Illinois Department of Transportation

SUBJECT: Aurora Municipal Airport
Aurora, Illinois
Kane County
Illinois Project Number: ARR-5201
SBG Project Number: 3-17-SBGP-TBD
Contract No. AU075
Item No. 06A, November 7, 2025 Letting
Addendum A

NOTICE TO PROSPECTIVE BIDDERS

REPLACE AIRFIELD
SIGNAGE, WIND CONES,
RUNWAY 15 AND 27
RUNWAY END
IDENTIFIER LIGHTS,
AND AIRPORT
ROTATING BEACON

SEQUENCE OF CONSTRUCTION NOTES

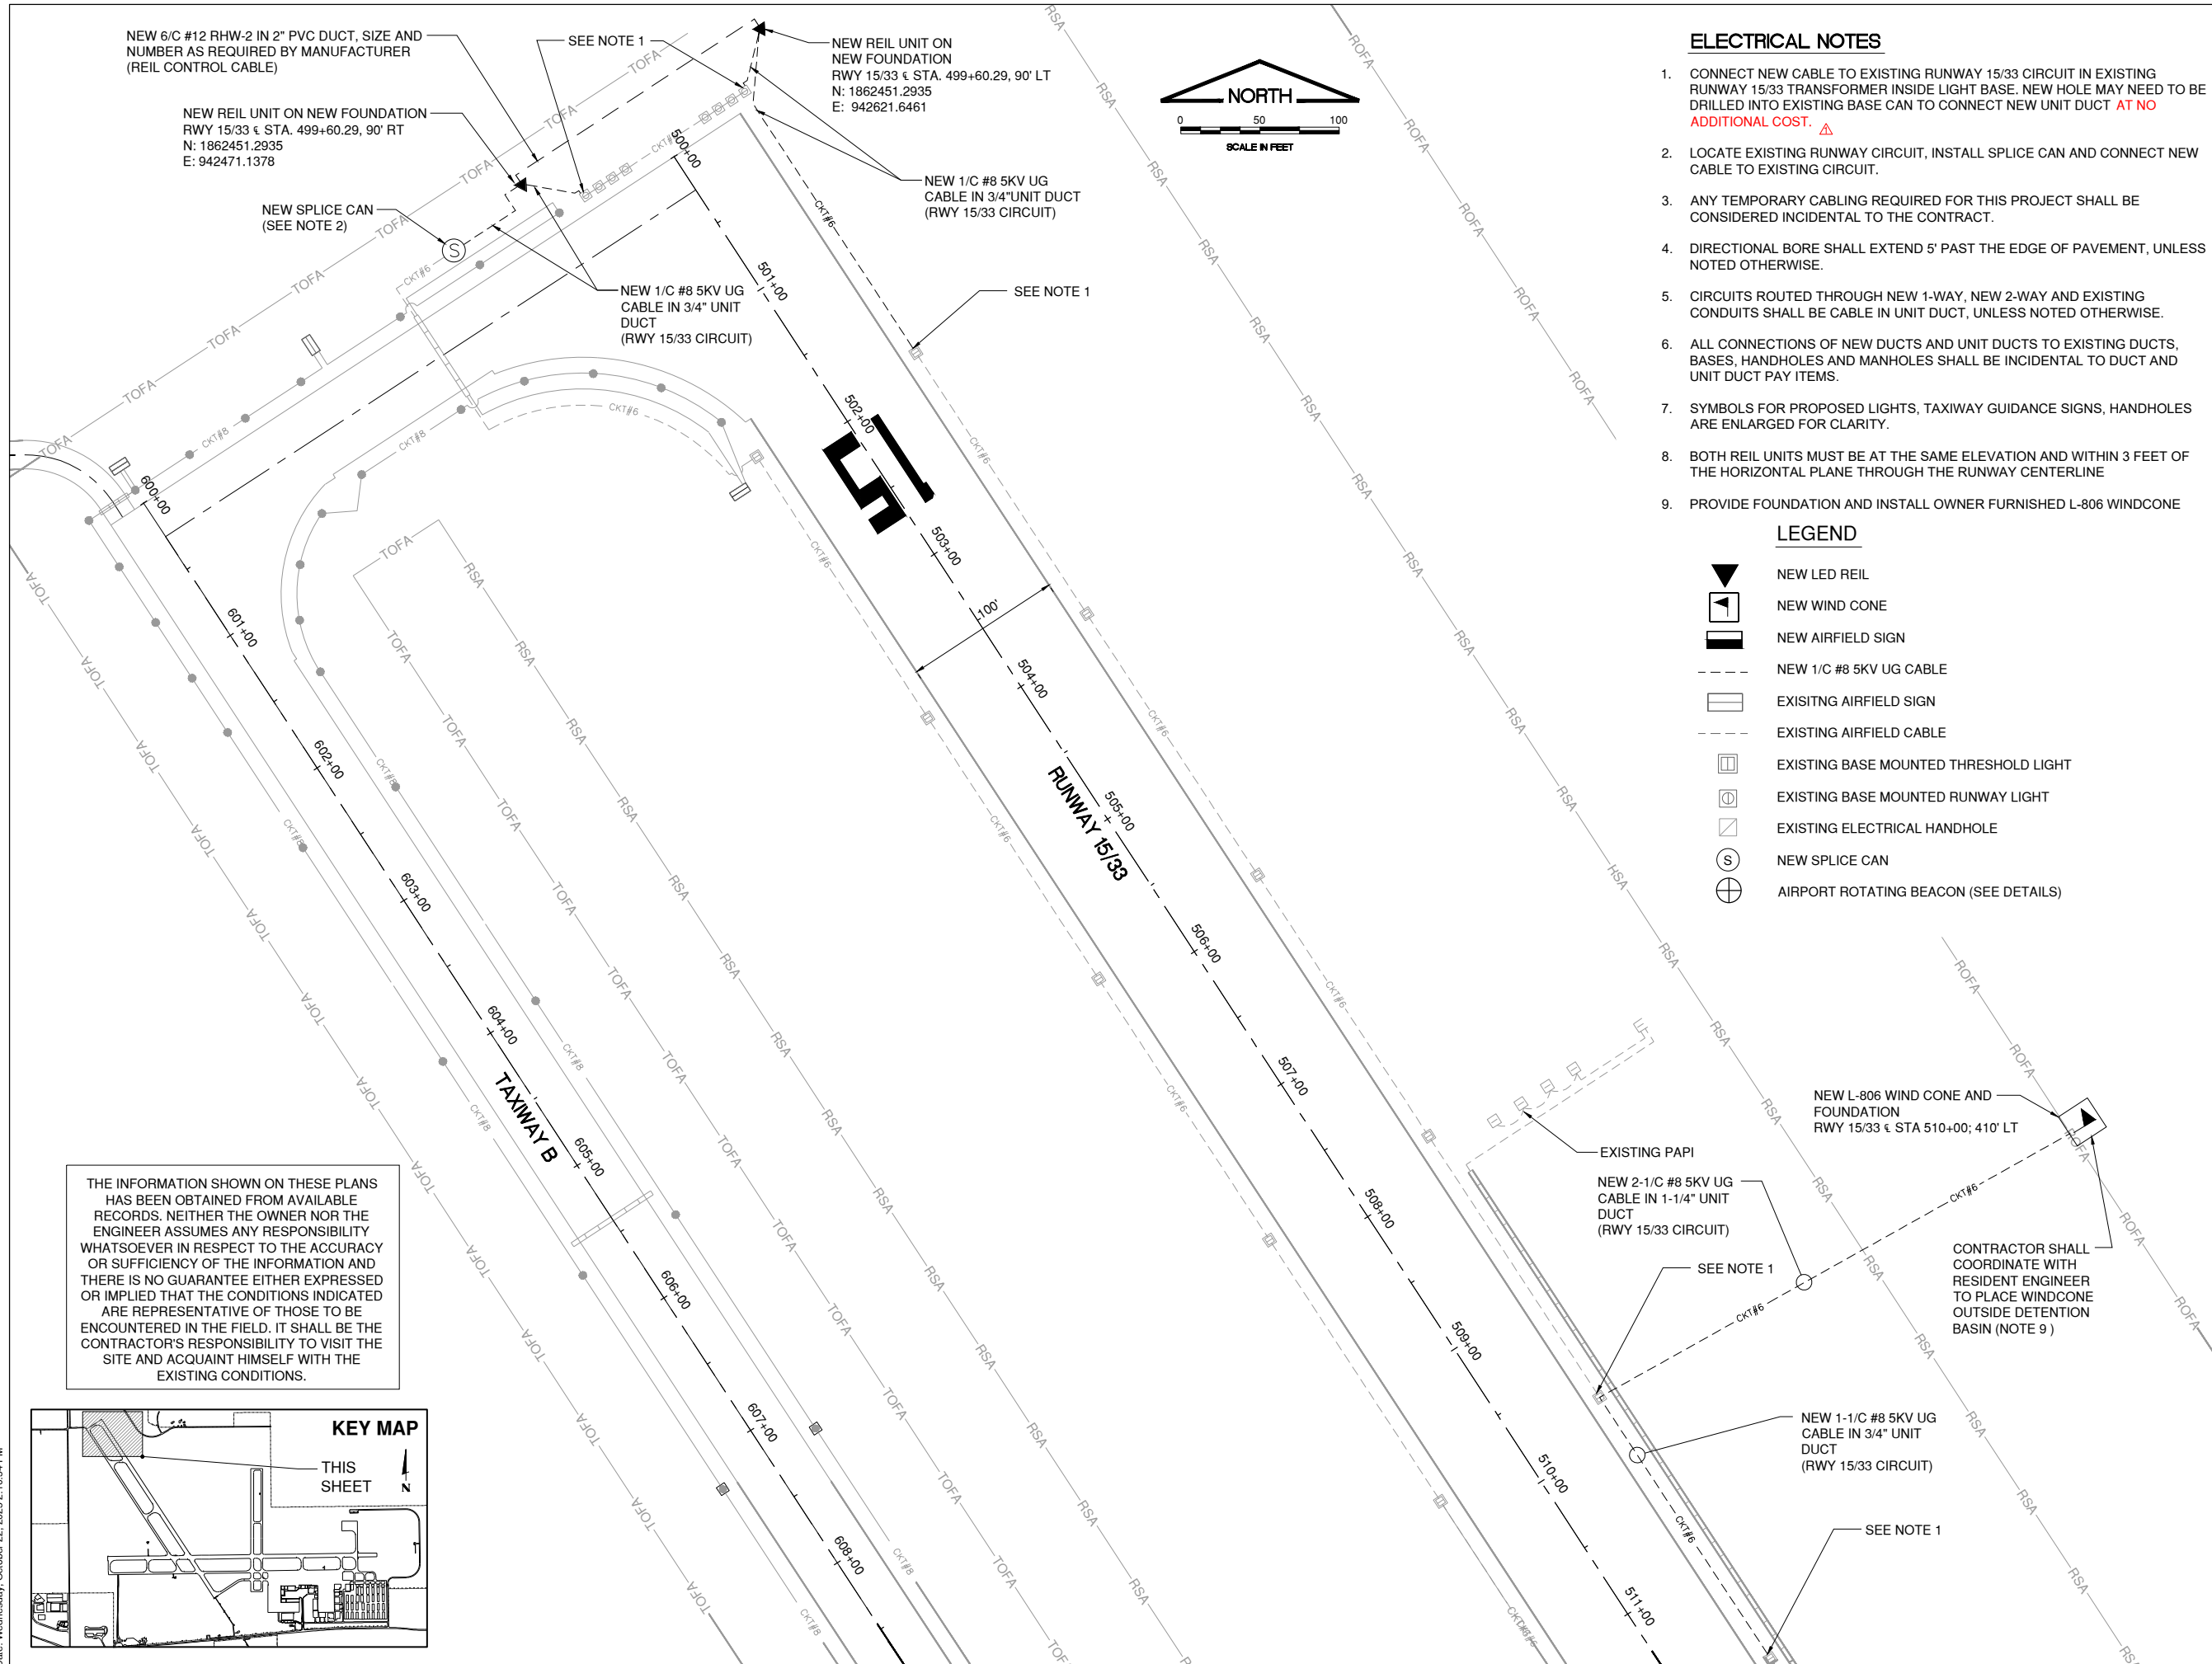
- b. Revise allowable work periods for Work Area 3 to three (3) calendar days.
4. Sheet 6 – Sequence of Construction Notes
 - a. Revise total contract time to 35 calendar days.

REVISE TOTAL CONTRACT TIME

PROPOSED IMPROVEMENTS - 1

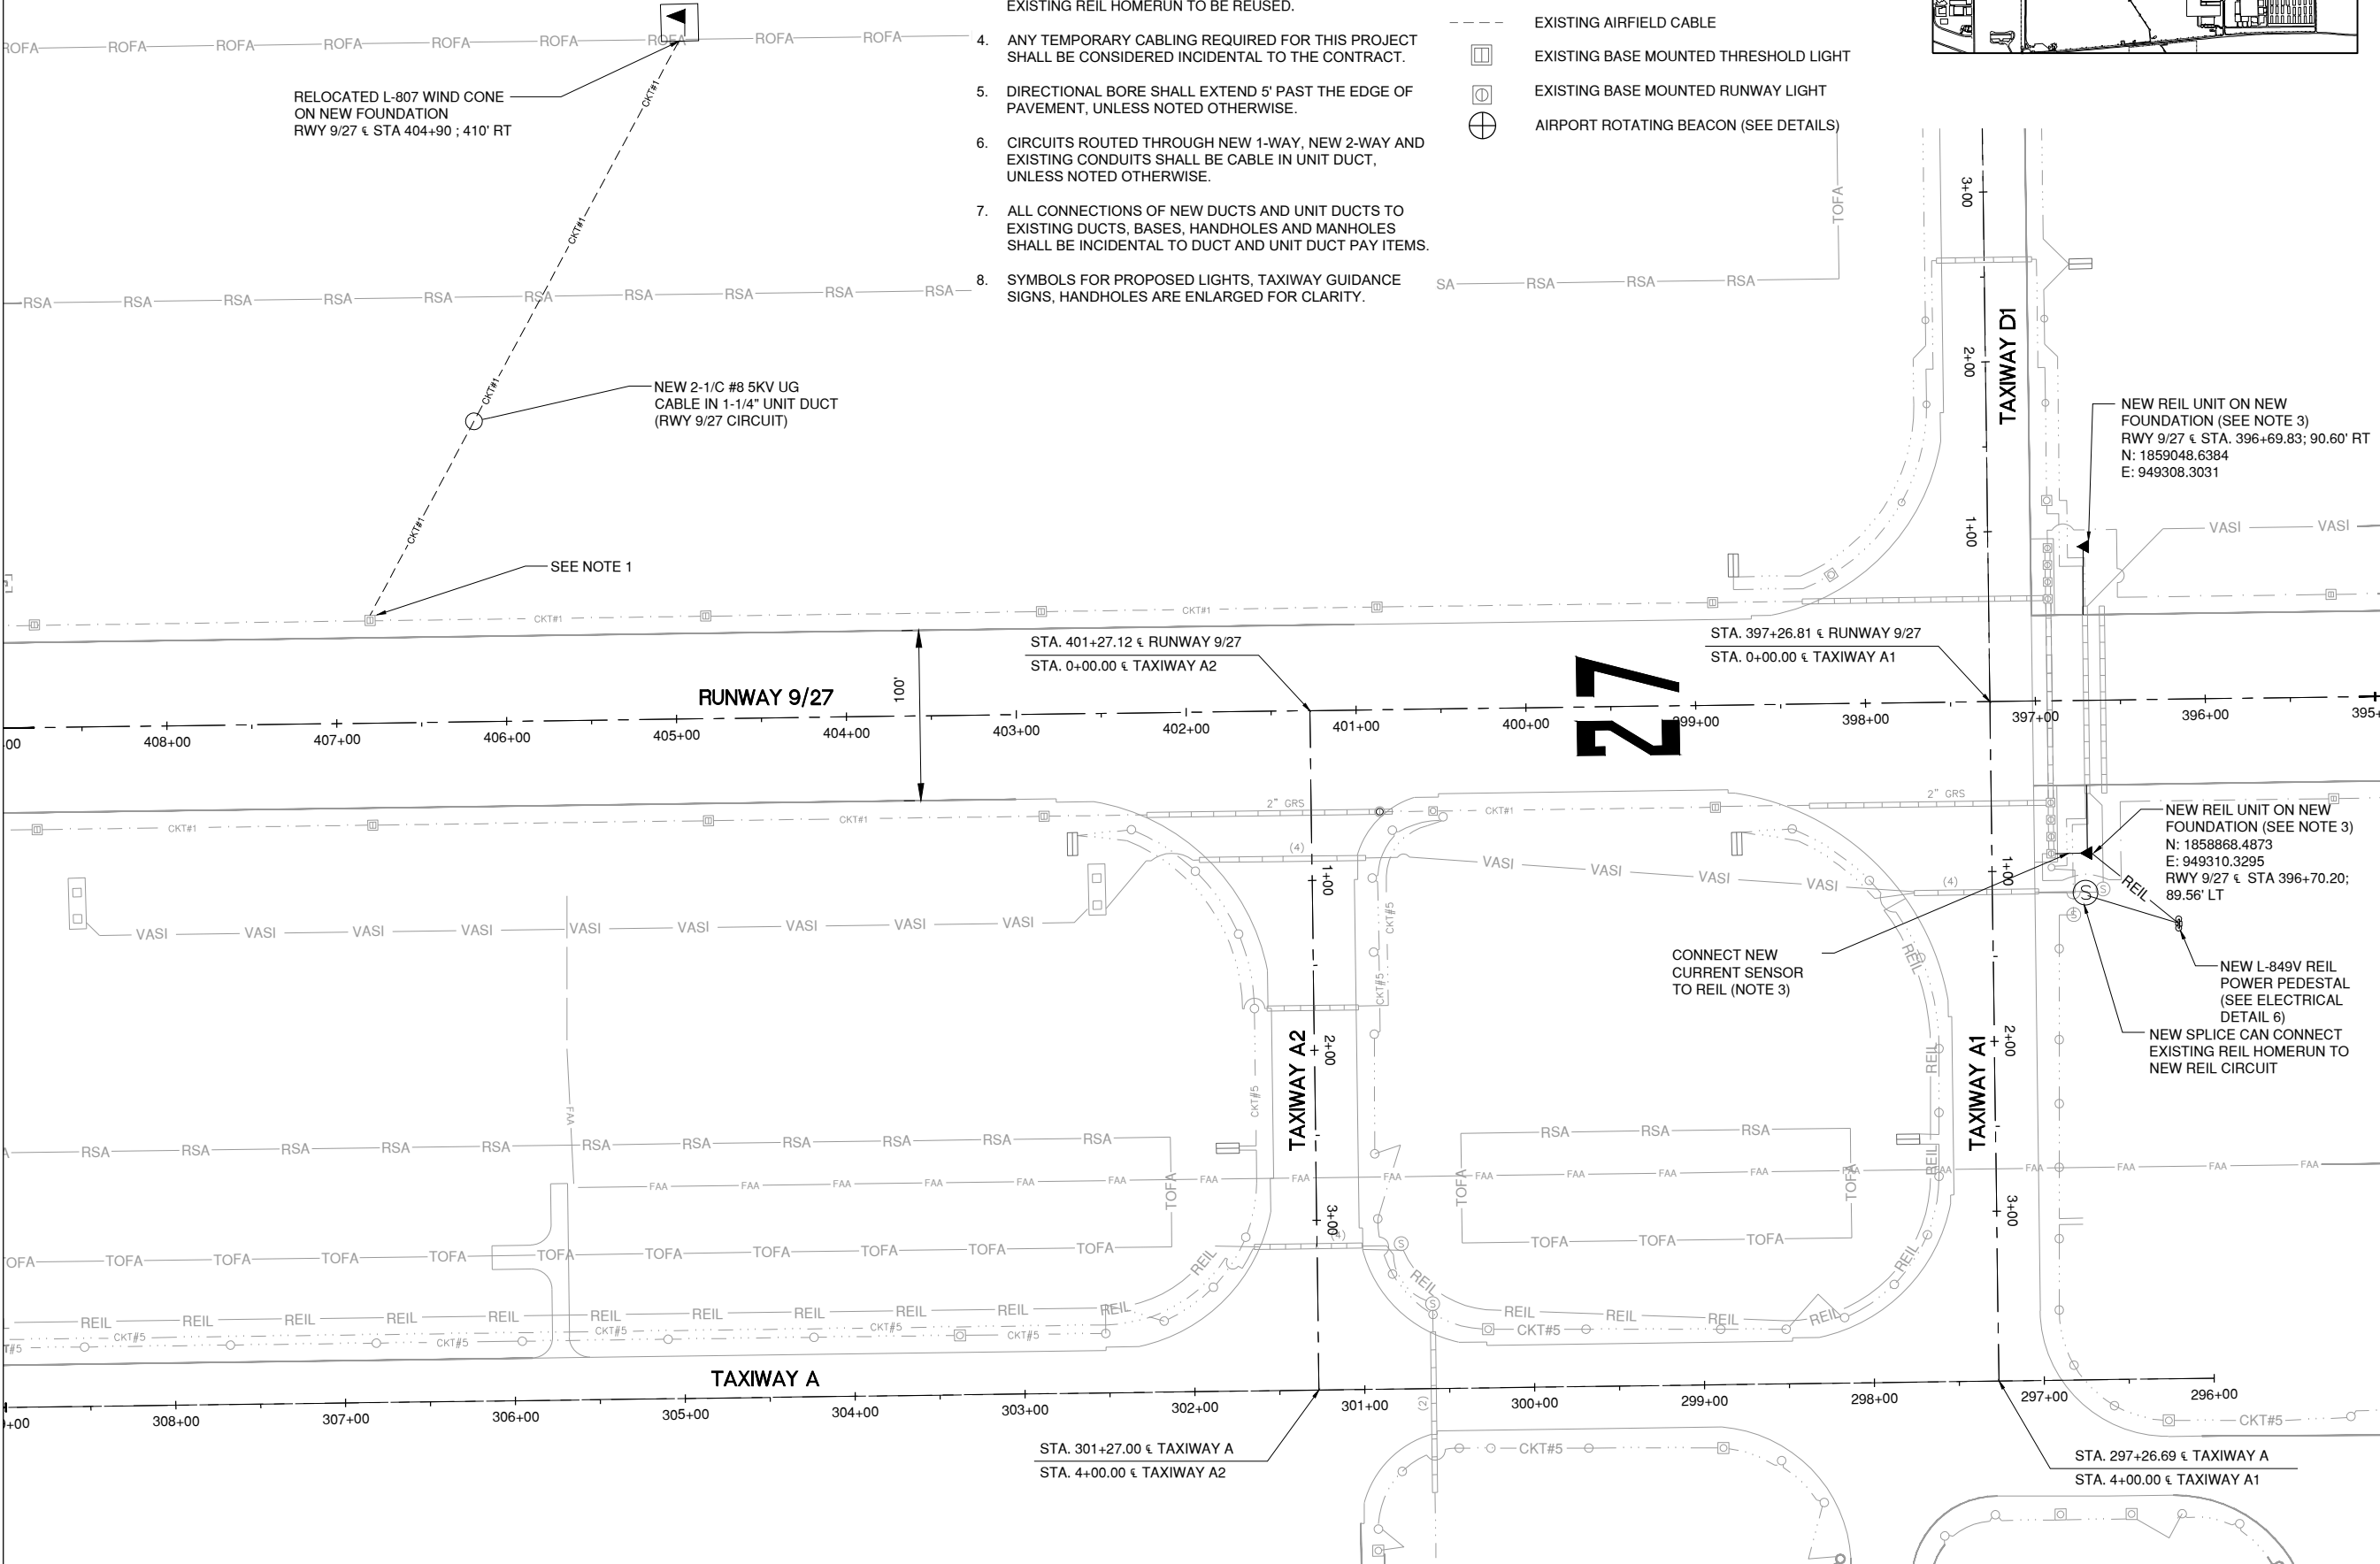
5. Sheet 13 – Proposed Improvements – 1
 - a. Revise Electrical Note 1.
6. Sheet 14 – Proposed Improvements – 2
 - a. Revise Electrical Note 1.
7. Sheet 15 – Proposed Improvements – 3

10/22/25 REVISE ELECTRICAL NOTE 1

1. CONNECT NEW CABLE TO EXISTING RUNWAY 9/27 CIRCUIT IN EXISTING RUNWAY 9/27 LIGHT BASE. NEW HOLE MAY NEED TO BE DRILLED INTO EXISTING BASE CAN TO CONNECT NEW UNIT DUCT **AT NO ADDITIONAL COST**.

10/22/25	REVISE ELECTRICAL NOTE 1
MARK	DATE	DESCRIPTION
IL PROJECT NO:		
CMT PROJECT NO:	25007812.00	
CAD DWG FILE:		
DESIGNED BY:	CMJ	
DRAWN BY:	JRO	
CHECKED BY:	DKP	
APPROVED BY:	DKP	
COPYRIGHT:		
SHEET TITLE		
PROPOSED IMPROVEMENTS - 3		
SHEET	15	OF 26

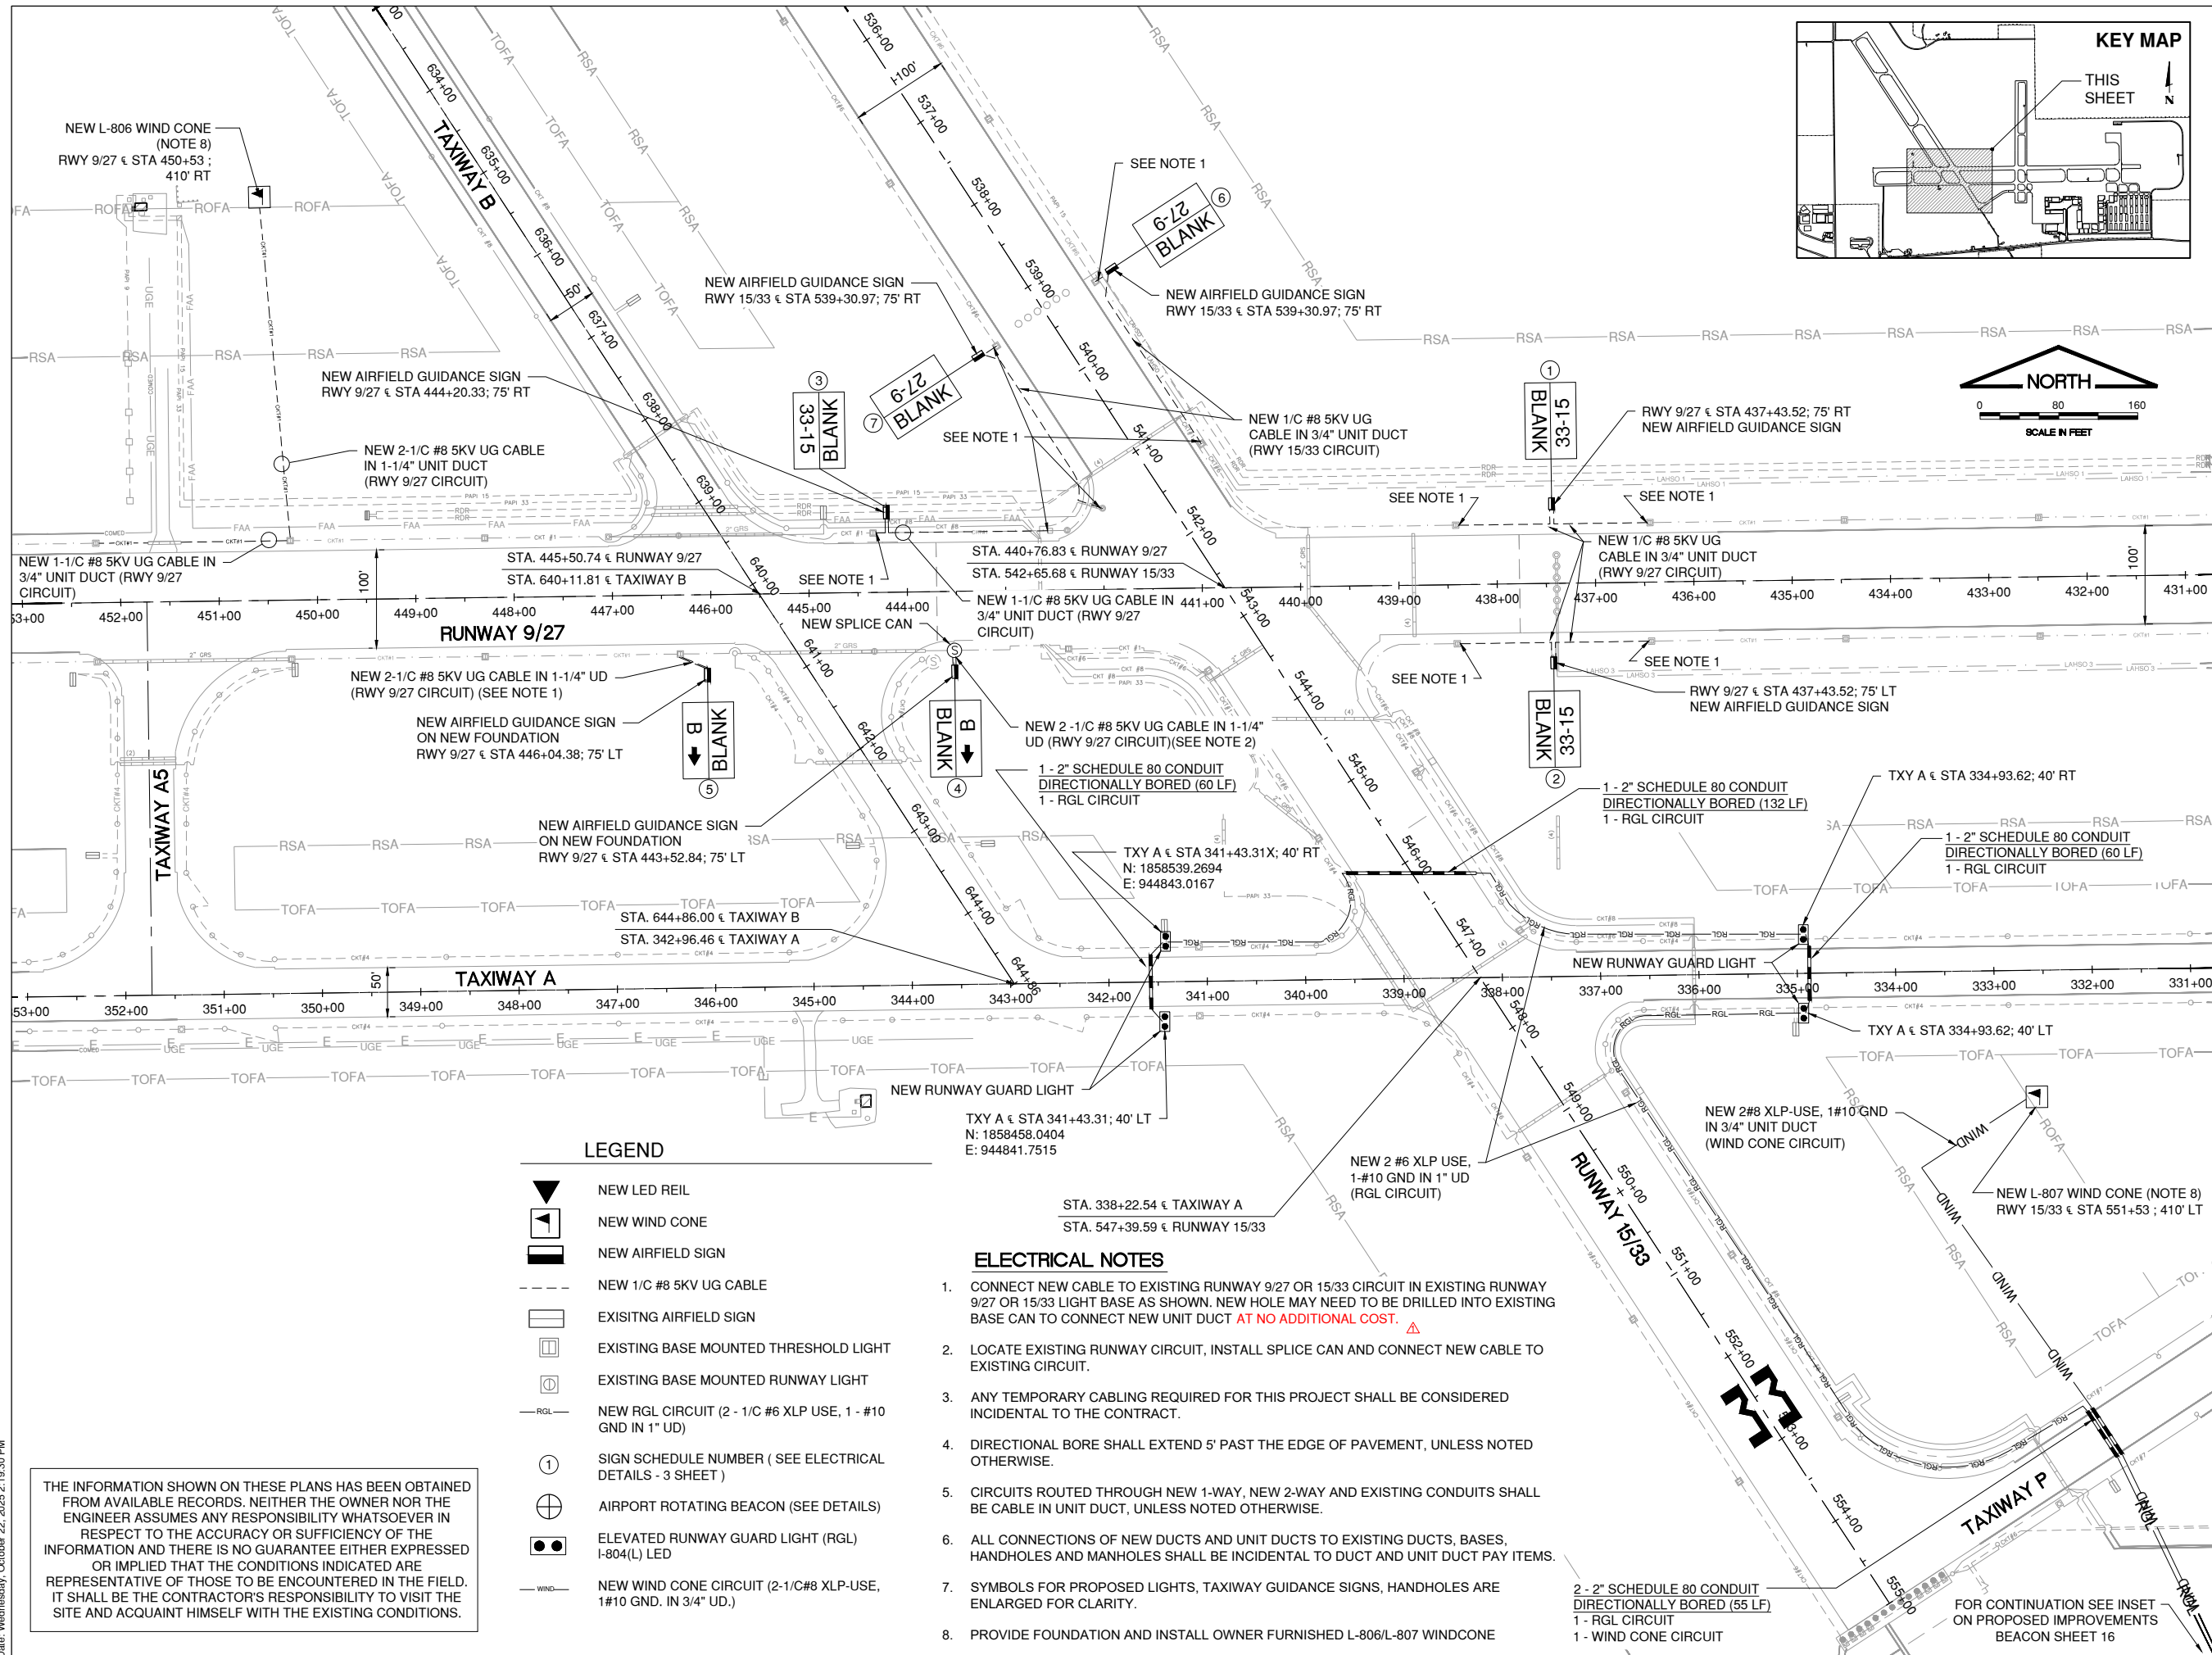
- a. Revise Electrical Note 1.
8. Sheet 20 – Electrical Details – 4
 - a. Add note to Detail 15.
 - b. Leave in Detail 14.
9. Sheet 23 - Electrical Details – 7
